From: Scott Hannah [<mailto:shannah@HeritageHomes.com>]
Sent: Friday, September 15, 2017 12:47 PM
To: Dawn McAlpine <Dawn.McAlpine@barrie.ca>
Cc: Carlissa McLaren <Carlissa.McLaren@barrie.ca>; Jim Dodd <jdodd@heritagehomes.com>; Barry Ward <Barry.Ward@barrie.ca>;
Subject: RE: PLN022-17 Request to be a delegation

APPLICATION FOR ZONING BY-LAW AMENDMENT - GREEN VALLEY CONSTRUCTION CORPORATION - 101 KOZLOV STREET (WARD 4)

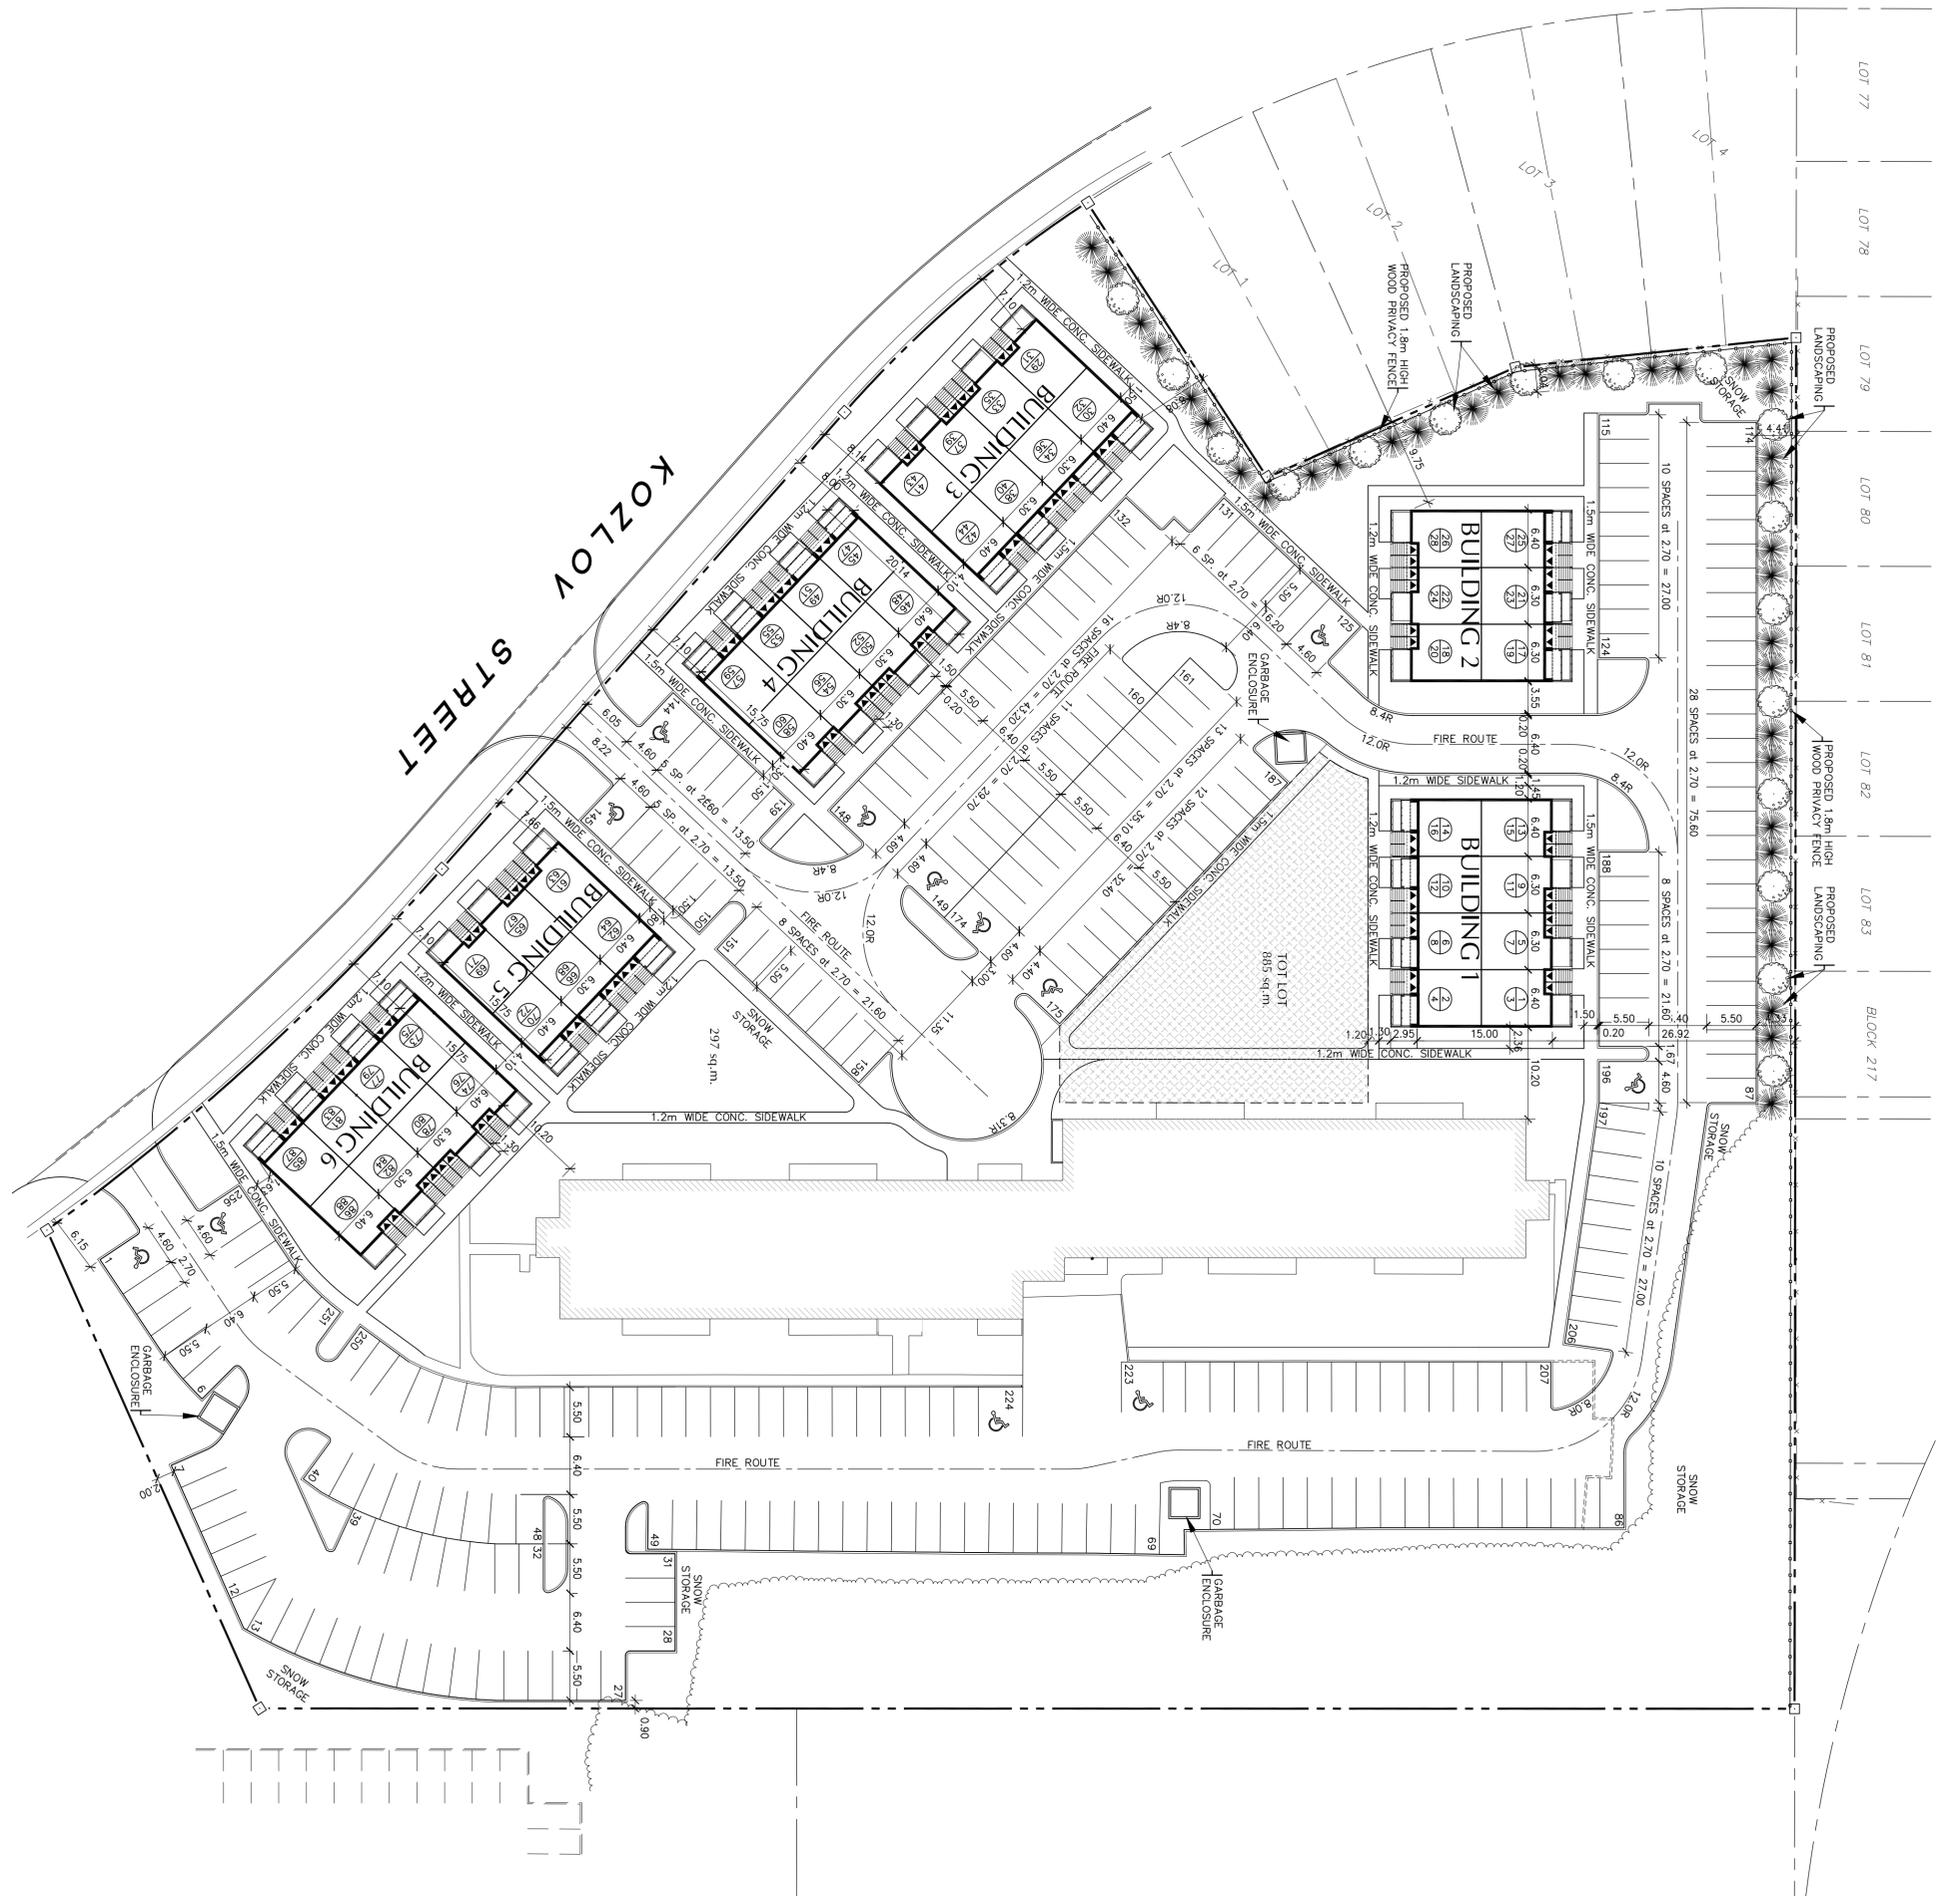
Dawn: I still intend to be a delegation at Council on Monday to speak to the resolution that came out of the General Committee this past Monday. Following the General Committee meeting on Monday our team has taken to heart the desire of Council to shift the internal driveway away the lot line shared with the existing homes along Koslov street and move it between the two proposed Buildings (Buildings 1 and 2). We have prepared a modified site plan showing this concept and have been able to achieve 88 units (a loss of 4 units rather than a loss of 8 units as stated in the resolution from General Committee). The attached plan now shows a 12 unit building and a 16 unit building with the driveway in between.

We view this new plan as satisfying the intent of the direction from Council and a win/win as it provides a substantive green area between Building 2 and the lot line which could be extensively landscaped. It also gains back 4 additional units (88 new units rather than 84) but still less than the 92 units in our current plan. The loss of units is a concern of our client as the original application had 120 units and we had already reduced the number to 92 in order to address issues raised by residents and staff. The attached plan also satisfies all of the zoning requirements for the site, including the special requirements for setbacks that have been requested by staff and which we have previously agreed to. We now view the latest concept plan as a positive change to the proposal.

- a) That a total of ~~eight~~ **four** units be removed from Building 1 ~~and or~~ Building 2, as shown on the Final Proposed Concept Site Plan identified in Staff Report PLN022-17, bringing the total number of new units in the development to ~~84~~ **88**;

- b) That parking be reduced accordingly and replaced with greenspace;
 - c) That the drive aisle west of building 2, as shown on the Final Proposed Concept Site Plan identified in Staff Report PLN022-17, be eliminated or moved to a location between Building 1 and Building 2.

2. That the following Special Provisions (SP) be referenced in implementing Zoning By-law 2009-141 for the subject lands:
 - a) Permit a maximum density of ~~94-90~~ **92** units per hectare, whereas a maximum density of 53 units per hectare would be permitted;

- d) Permit a minimum parking ratio of 1.15 spaces per unit, whereas a minimum of 1.5 spaces per unit would be required;
 - e) That a minimum outdoor amenity area of ~~1,104~~ **1056** square metres be provided on site, of which a minimum of 834 square metres shall be provided in a consolidated form, whereas a minimum outdoor amenity area of ~~1,104~~ **1056** square metres would be required to be provided in a consolidated form;
